Re: Final Subdivision Plat Approval
2, 4 & 6 Massaro Court

Re: Final Subdivision Plat Approval
2, 4, & 6 Massaro Court

Below is a response letter affirming that the approval conditions listed on the May 8, 2023, Planning Board resolution will be completed to the satisfaction of the Planning Board as required for final subdivision approval of the 3-lot subdivision at 2, 4, & 6 Massaro Court:

TURNING TEMPLATE LOTS 1 AND 2

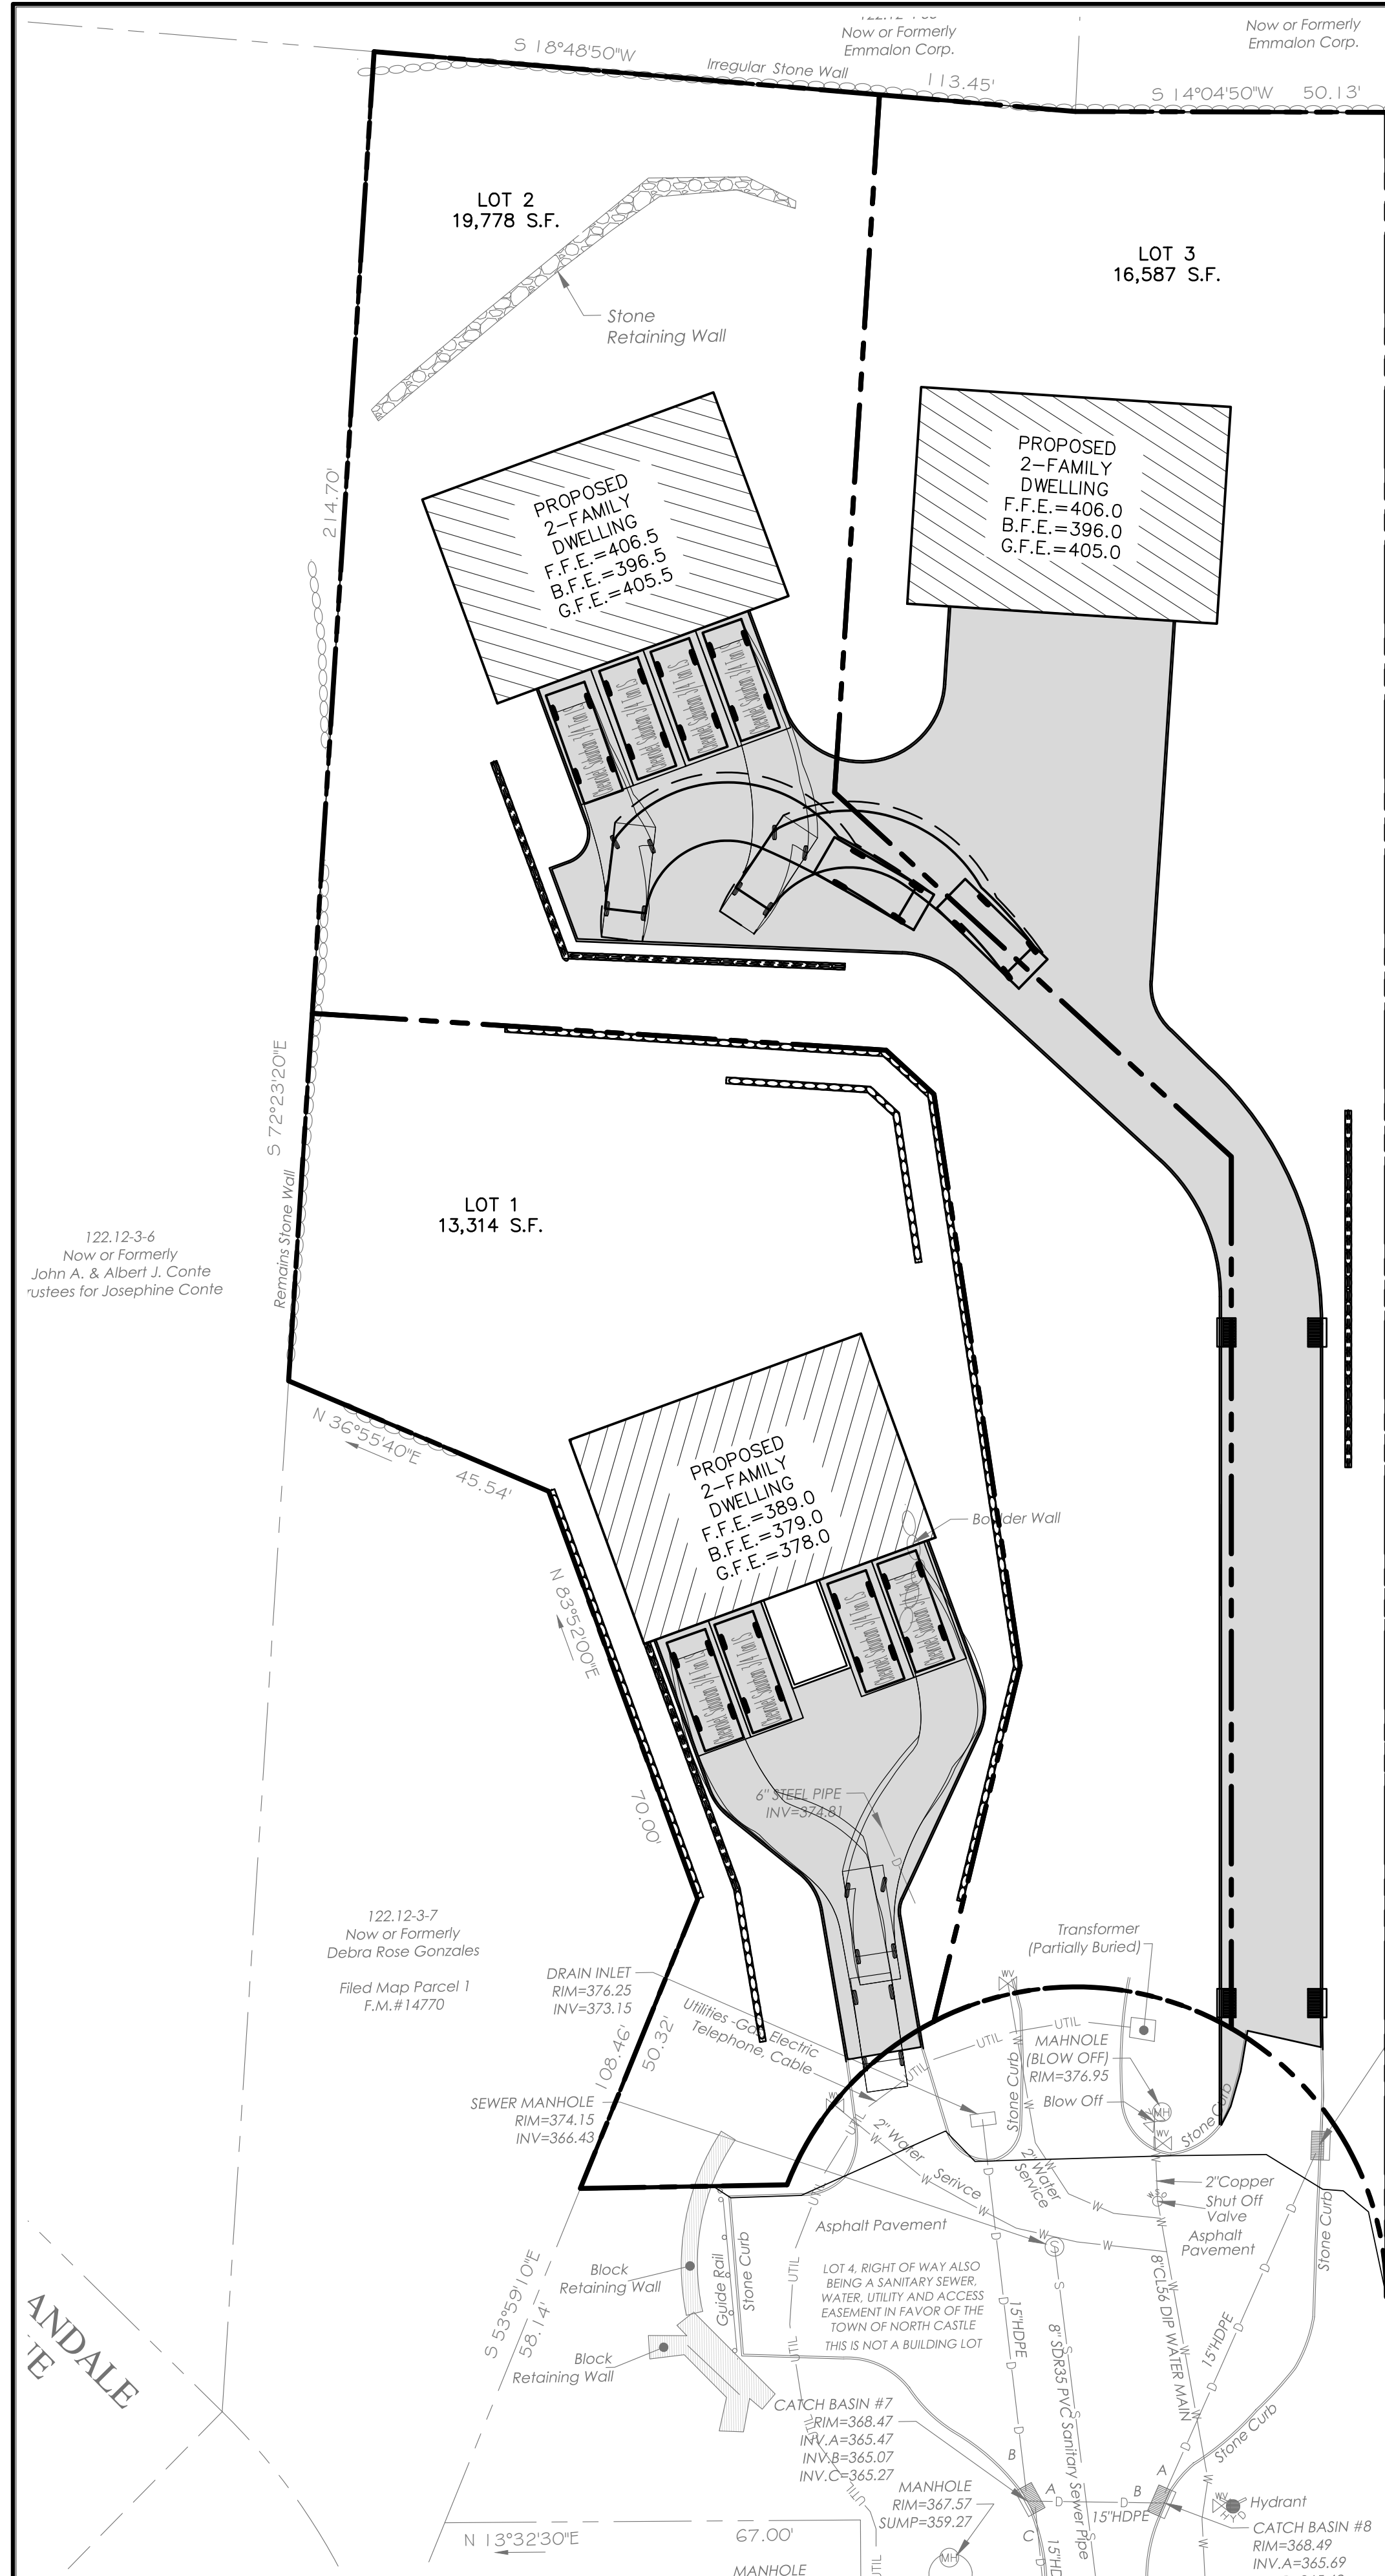
7. The Applicant shall revise the vehicle backup area on Lot #2 in an effort to improve the turning maneuver required to exit the northern parking spaces, to the satisfaction of the Town Engineer.

To be completed with Site Plan Approval for Lot #2.

PROFILES

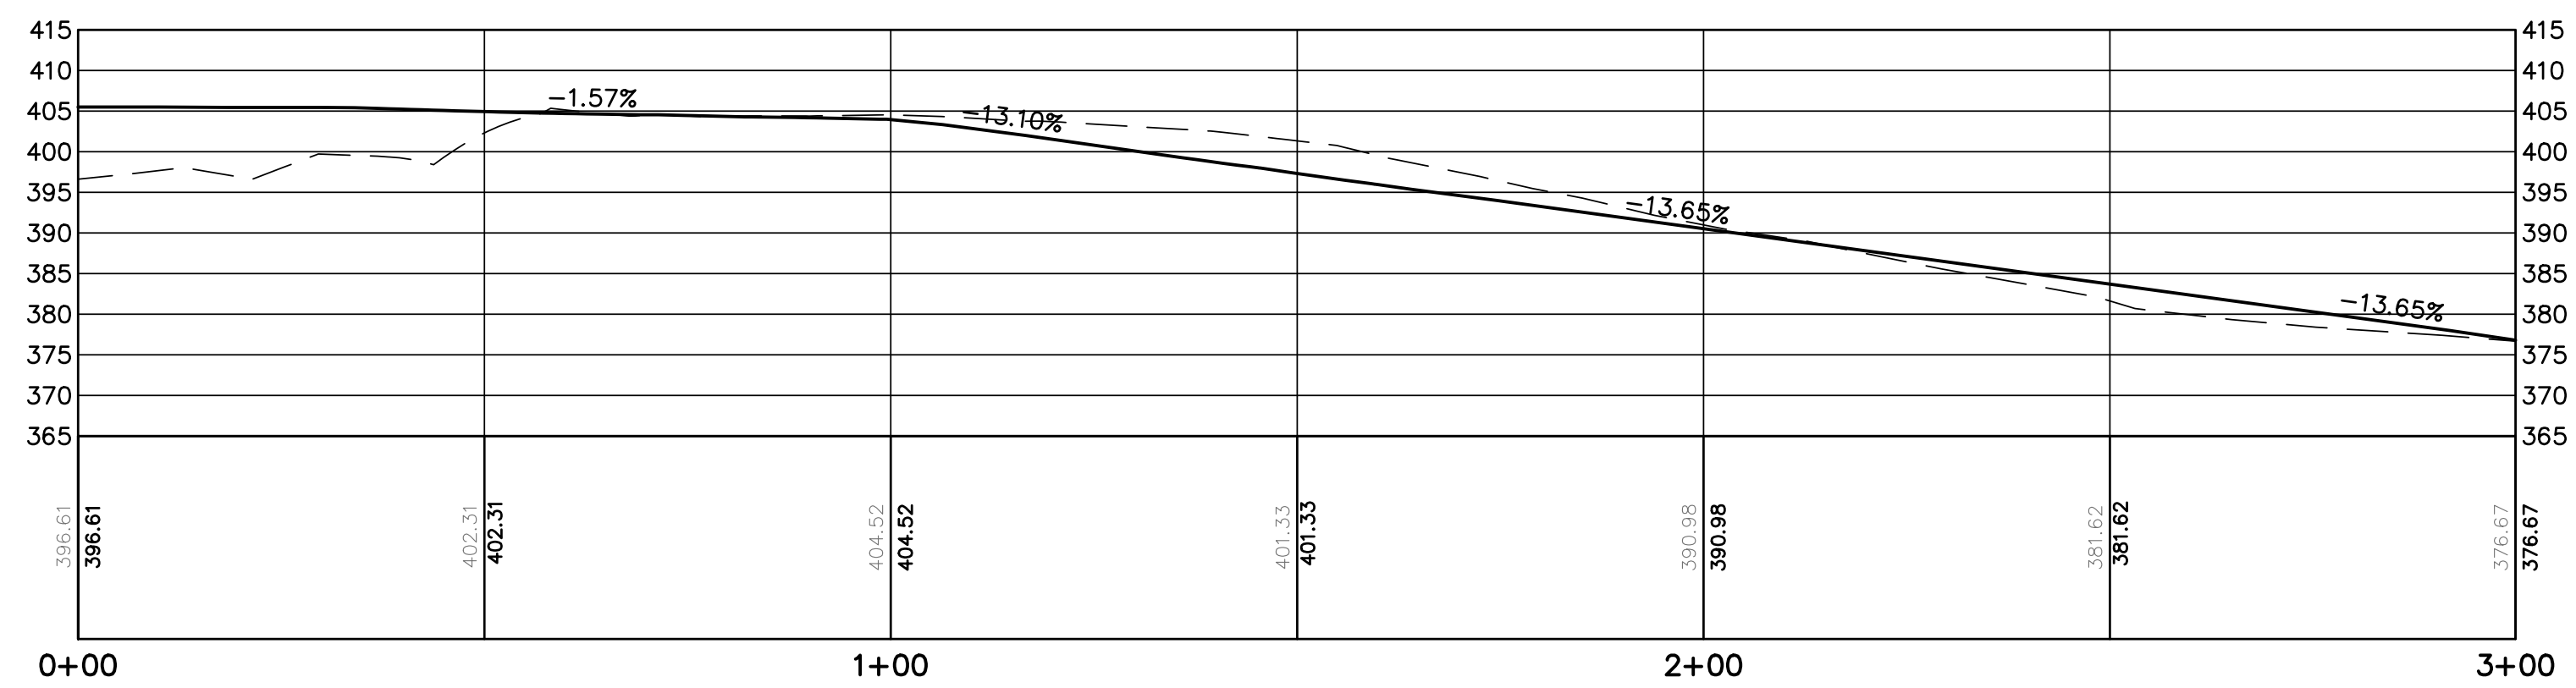
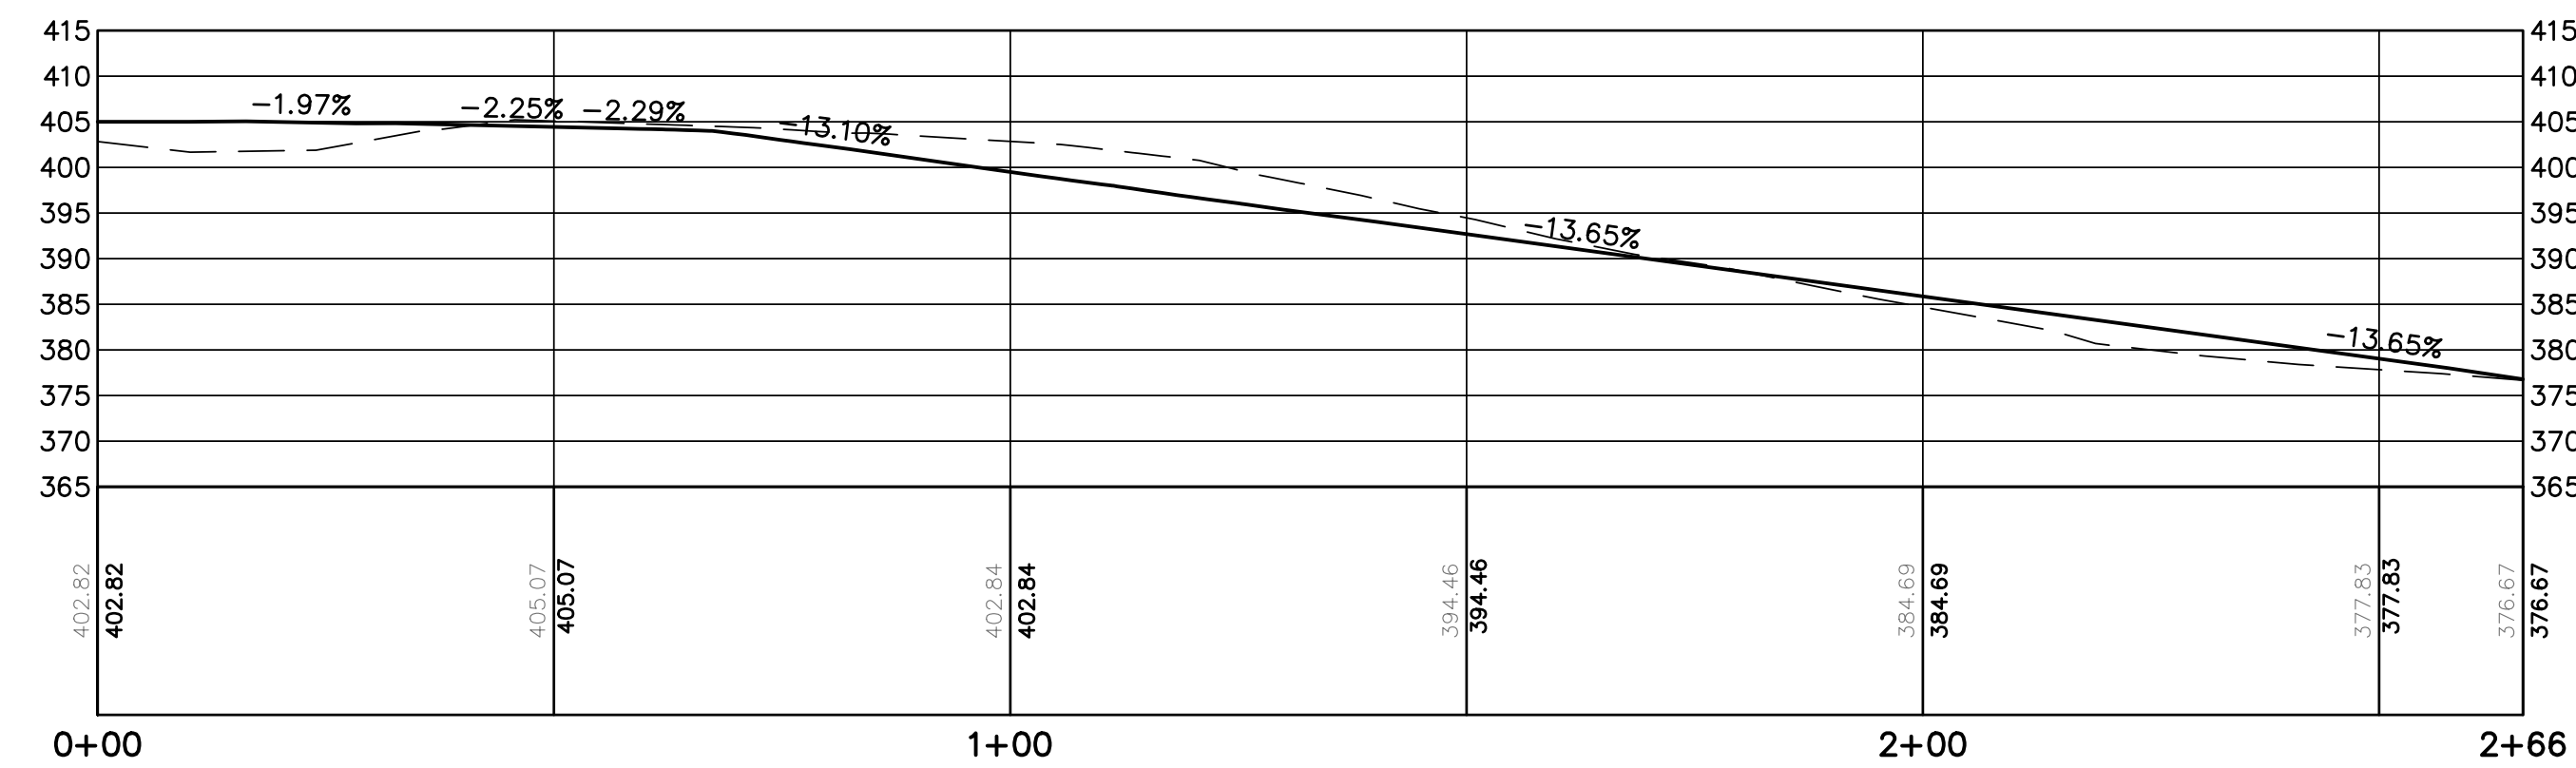
6. The Applicant shall revise the proposed driveway profile for Lot #1 and the common driveway profile for Lots #2 and #3. Driveway profiles shall be revised to comply fully

with the Town regulations for driveways. Driveway profiles shall include vertical curves at changes in grade. Proposed site grading shall be revised to reflect changes in the driveway profile, to the satisfaction of the Town Engineer.

To be completed with Site Plan Approval for the individual lots.
